August 3, 2015

Mr. Marc Ferdas
Decommissioning And Technical Support Branch Chief, Region I
US Nuclear Regulatory Commission
2100 Renaissance Blvd, Suite 100
King of Prussia, PA 19406-2713

Docket Number NRC-0000-1501-1626

Thank you for your time in our July 17, 2015 call between the Connecticut Department of Energy and Environmental Protection (henceforth, the Agency) and the Nuclear Regulatory Commission (NRC) Regional representatives to discuss the state's concerns with the radiological remediation of the former naval nuclear program fuel manufacturing site at 79 Shelton Avenue in New Haven, CT [United Nuclear Corp New Haven (UNC NH), license number SNM-386, docket no. 70-371].

Figure 1
Site Map of Buildings 9H, 10H, and 11H

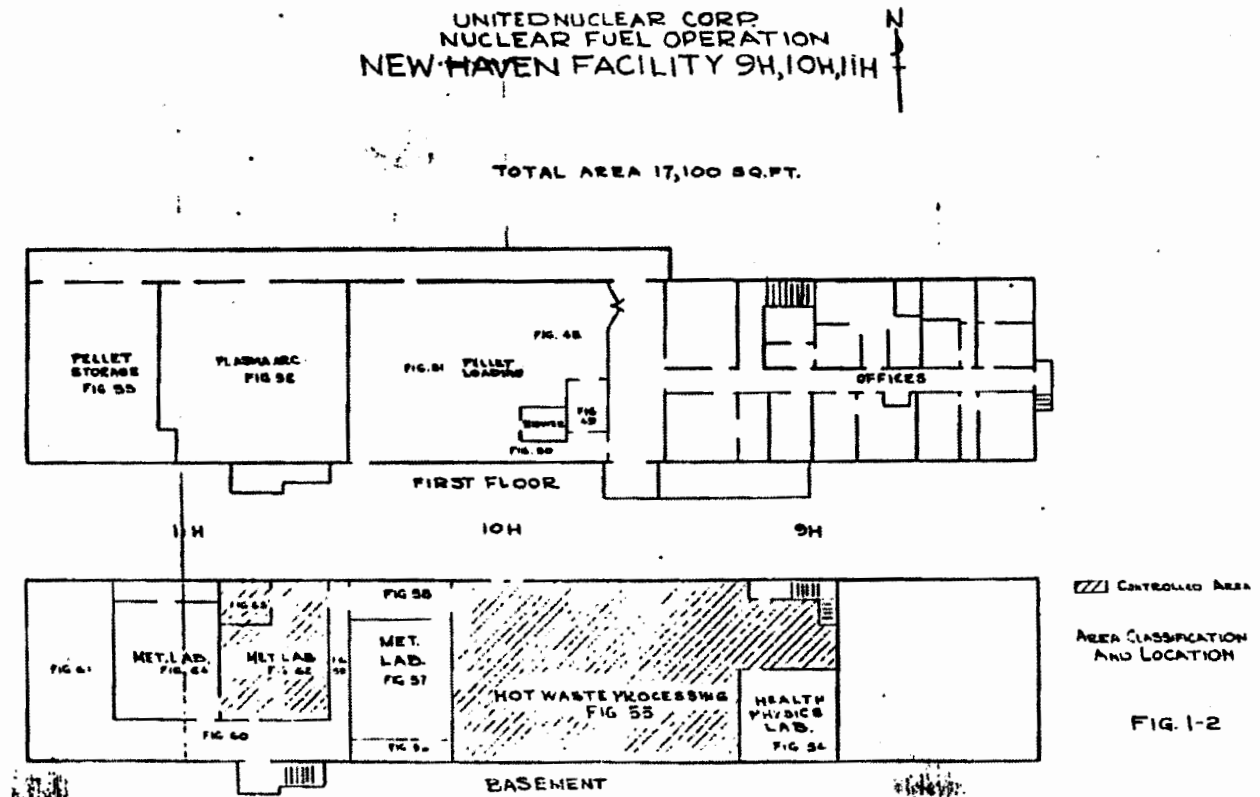
1. The Oak Ridge Associated Universities (ORAU), operating under the Oak Ridge Institute for Science and Education (ORISE), report that you referenced ("Independent Confirmatory Survey Results For The Utility Trench Characterization, United Nuclear Corporation Naval Products Site, New Haven, Connecticut," April 2015) provides independent confirmatory investigations and analysis *only* of the soils beneath the utility trenches.
2. Site survey maps indicate "Hot Waste Processing," "Met Lab," and other radiological controlled areas were located in the basements of the buildings 9H, 10H, and 11H (Figure 1). The

foundations of these buildings remain and appear to have been filled in (Figure 2). The Agency is not aware of any radiological survey that properly characterized these basement areas.

Figure 3
Duct Work

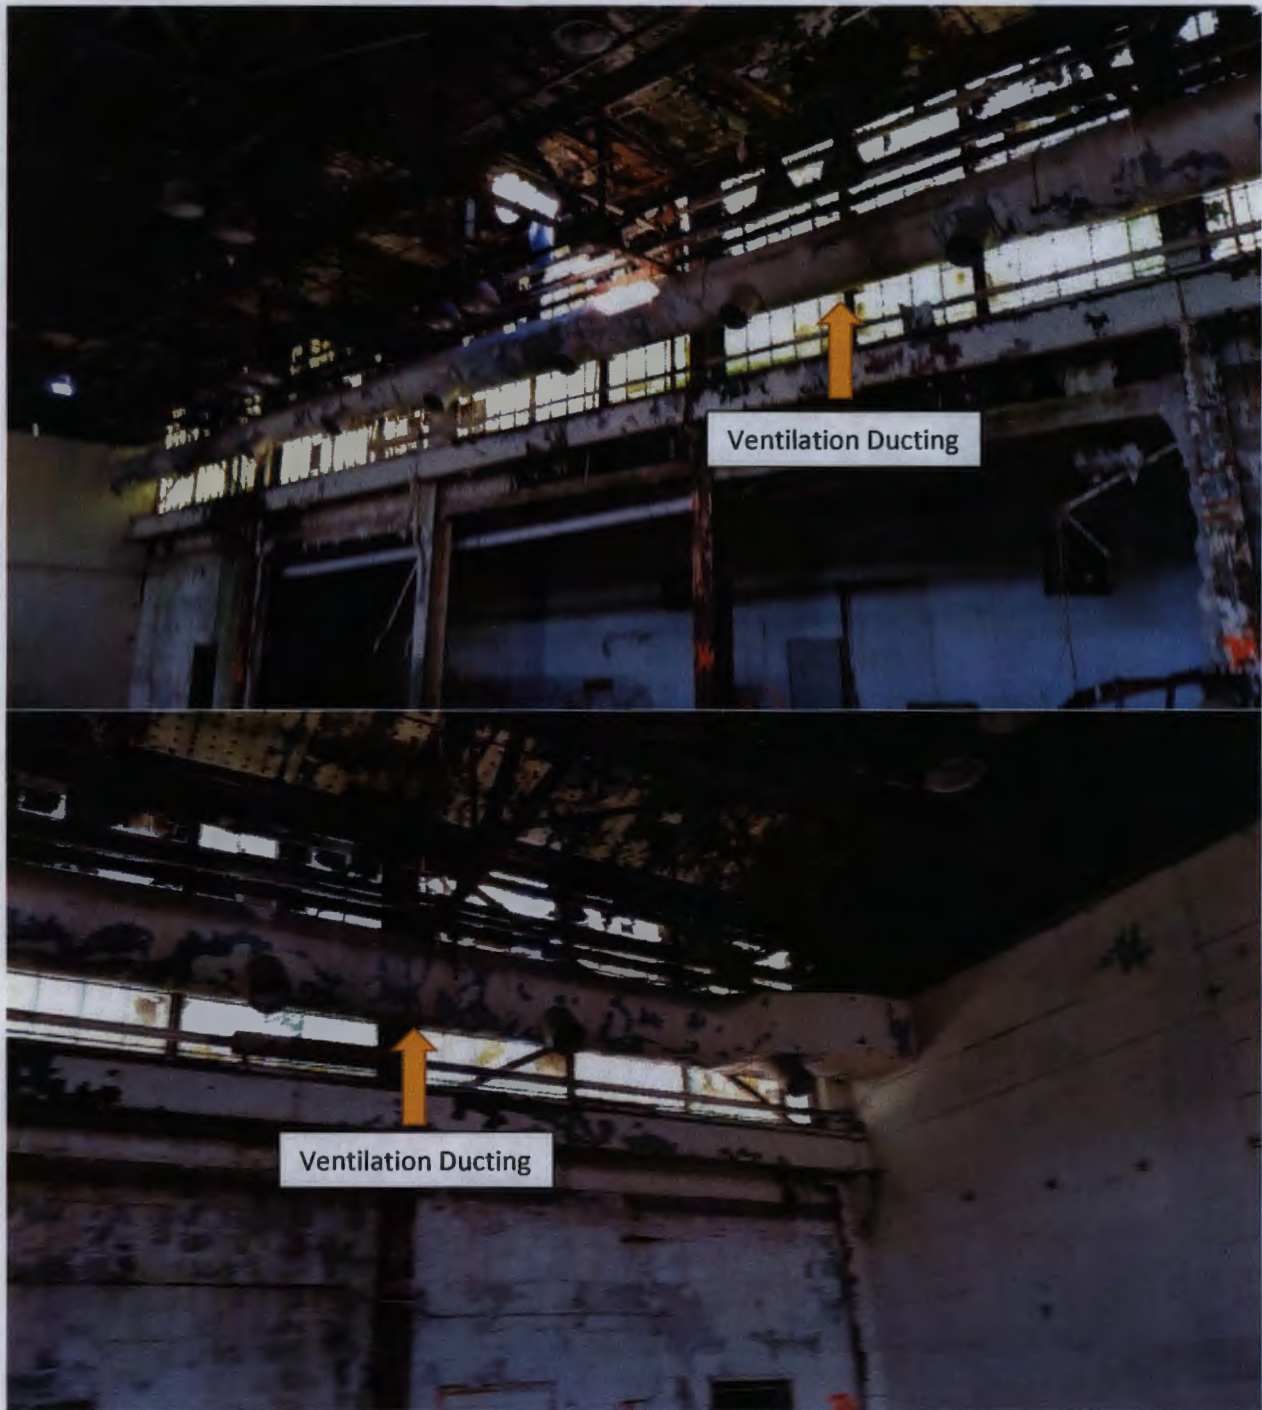
3. The facility appears to have ventilation ducting in the processing areas of building 3H that is of the type typically used for isolated radiological work (i.e. "hot box" or "glove bag") (Figure 3). The Agency is not aware of any record of a radiological survey or assessment of this ventilation ducting. The Agency believes that a complete characterization should determine the degree of radiological contamination of the ventilation system.

Figure 4
Debris Interference

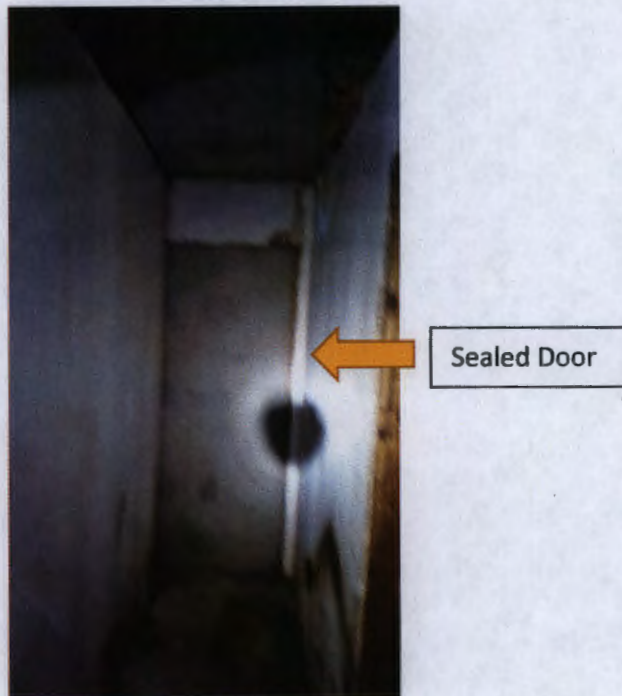
4. The entire floor surface has not been scanned due to debris that has not been moved and room access that has been sealed. Debris and equipment storage has not been removed to systematically survey the floor surface of buildings 3H and 6H (Figure 4). Portions of the facility have been closed off by building modifications to prevent trespass into previously unsecured areas (Figure 5). The Agency is concerned that these areas are not accessible for survey and characterization. In 2012, the Agency conducted limited in situ radiation measurements and identified a localized area of concern in an unrestricted area. A concrete core bore was taken and sent for laboratory radiological analysis (Figure 6). This gamma spectrum analysis indicated that the average residual total uranium concentration $\left(\frac{1.06 \times 10^7 \text{ pCi}}{3539.2 \text{ g}} = 3000 \frac{\text{pCi}}{\text{g}}\right)$ of this core bore was more than six times the derived concentration guideline of 435 picoCuries per gram (pCi/g) required to comply with the state of Connecticut's 19 millirem per year site release criterion (Enclosure 1). Based upon our limited independent survey and analysis, the Agency is concerned that undetected contamination (i.e. "hot spots") may remain.
